IEC 62908-12-10
Edition 1.0 2017-06

TOUCH AND INTERACTIVE DISPLAYS –

Part 12-10: Measurement methods of touch displays –
Touch and electrical performance

CORRIGENDUM 1

Figure 12 – Linearity definition

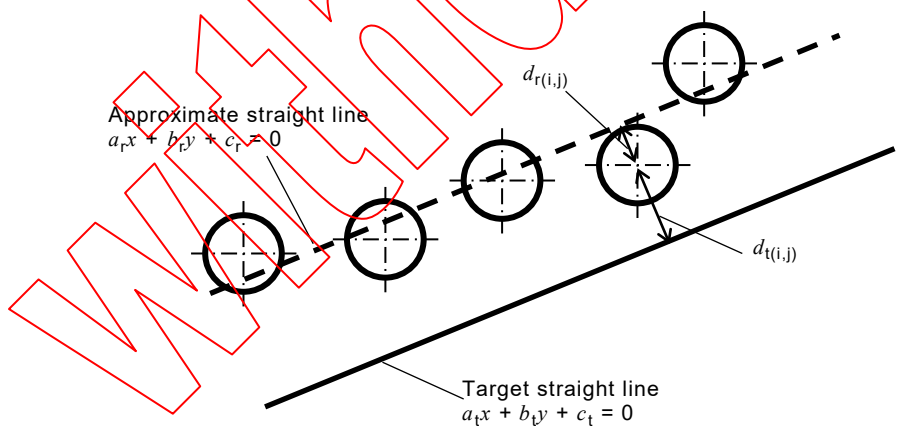
Replace Figure 12 with:

The distance between the centre of the reported point and straight line is calculated by the formula in Figure 12.

Replace Equations (17) and (18) with:

$$d_{r(i,j)} = \frac{|a_r x_{r(i,j)} + b_r y_{r(i,j)} + c_r|}{\sqrt{a_r^2 + b_r^2}} \quad (17)$$

$$d_{t(i,j)} = \frac{|a_t x_{r(i,j)} + b_t y_{r(i,j)} + c_t|}{\sqrt{a_t^2 + b_t^2}} \quad (18)$$
